<b>SERVICE BULLETIN</b>	30.05.2023
		No. 01-23

Gates fuel lines

The bulletin applies to Aviation Artur Trendak gyroplanes manufactured up to 2 years ago from the issue of the bulletin, equipped with Gates fuel lines, and gyroplanes with fuel lines replaced during this period.

Figure 2\_Fuel system scheme

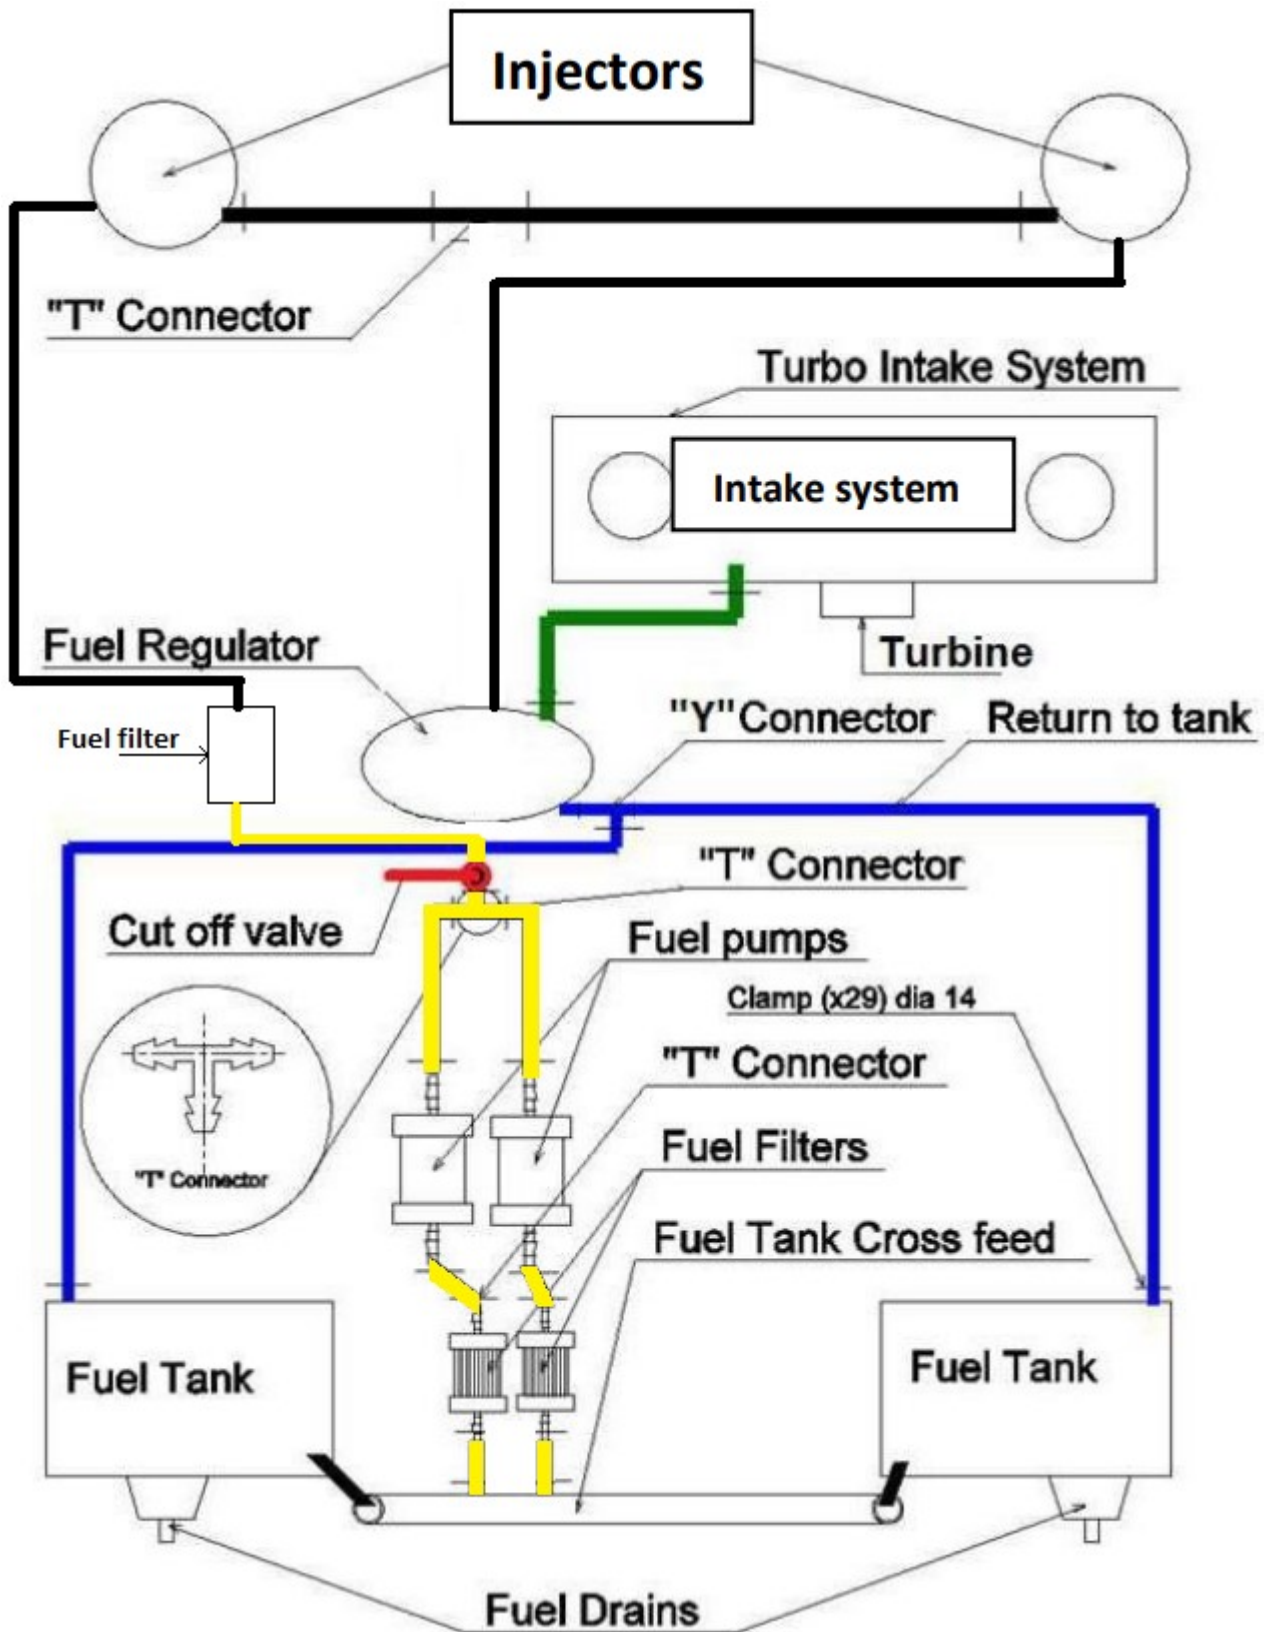
In the diagram above, the fuel lines necessary to locate are marked in yellow and blue.

In fact, these fuel lines are black, and some of them are additionally covered with a red cover tube.

Figure 3\_Fuel system components

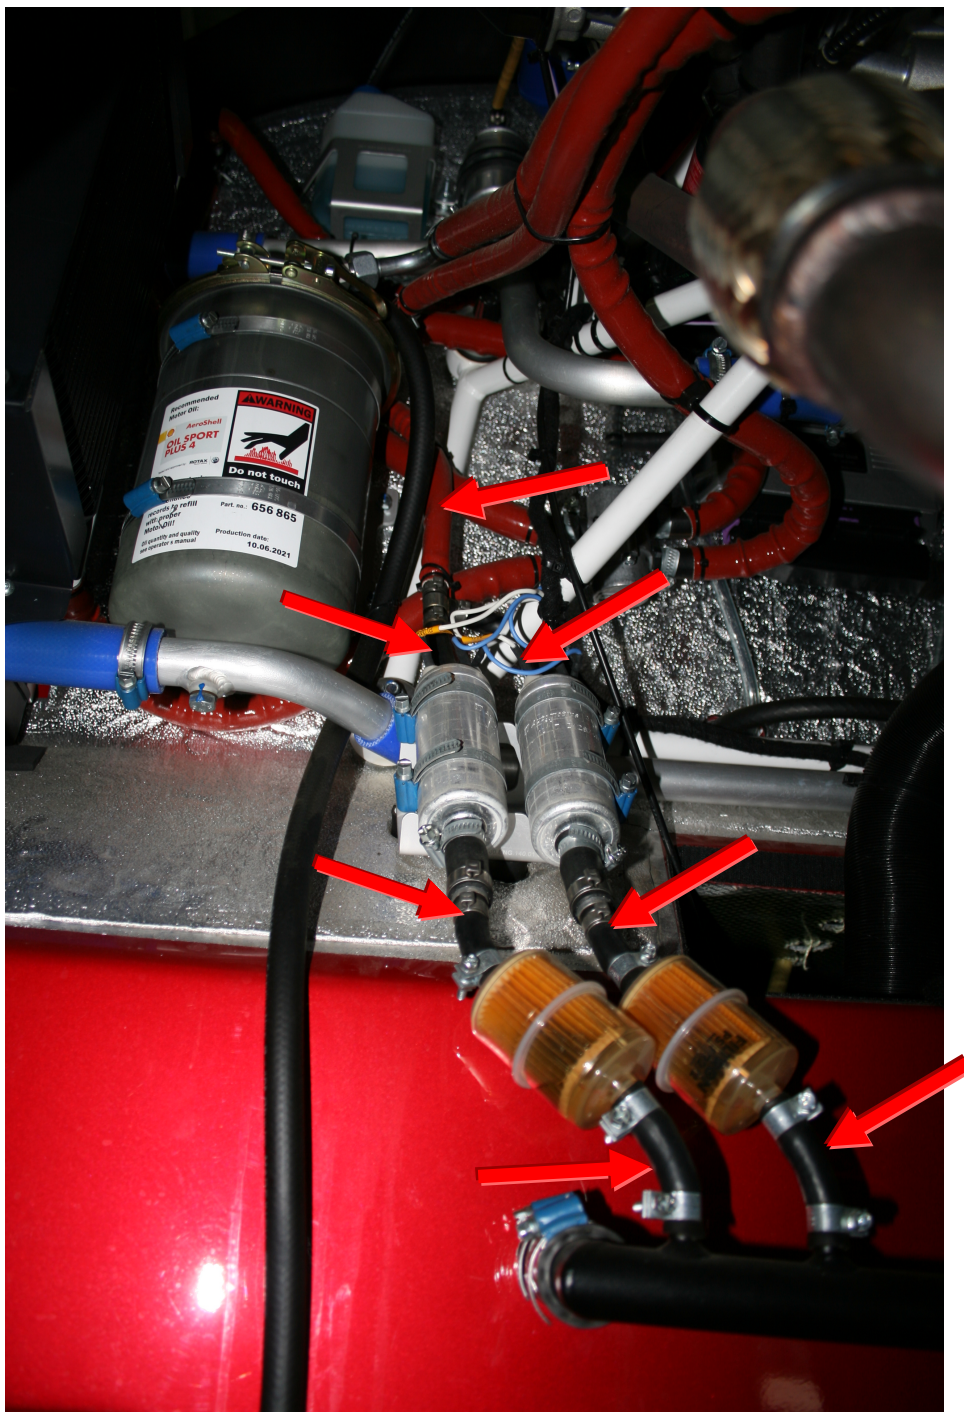
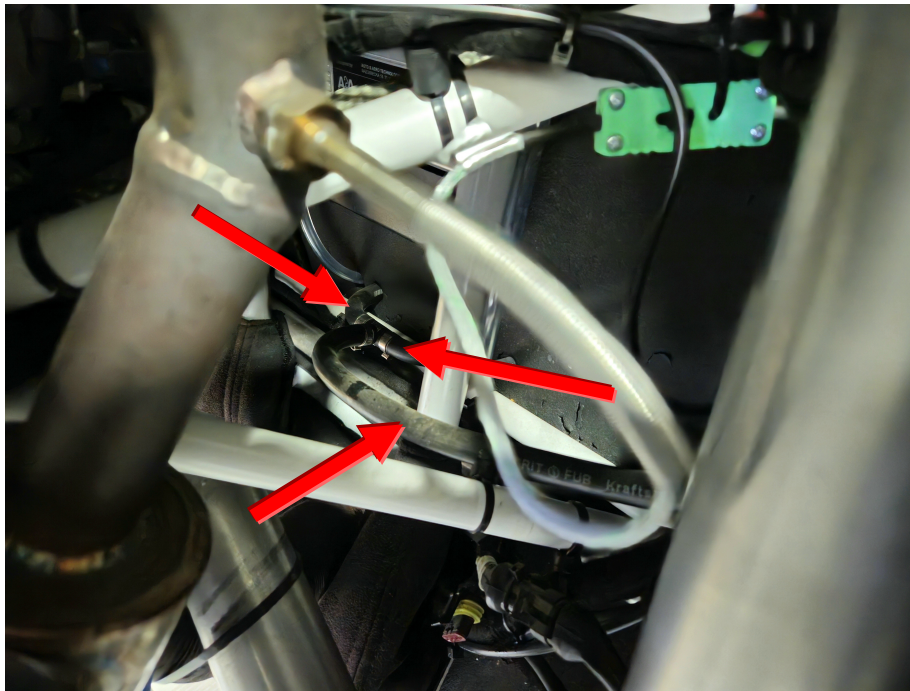
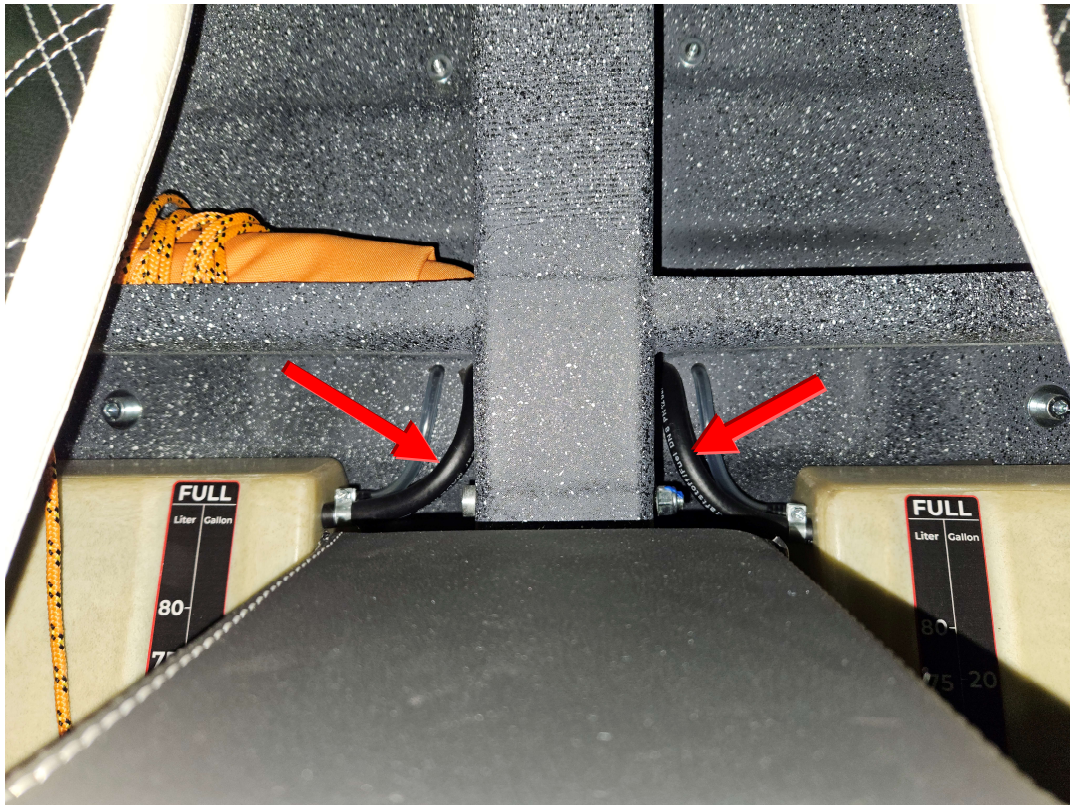
The sections of fuel lines to be looked for are indicated by red arrows in Figure 3-7.

4. If the fuel lines are made by Gates or cannot be identified, they must be replaced with new ones supplied by Aviation Artur Trendak.
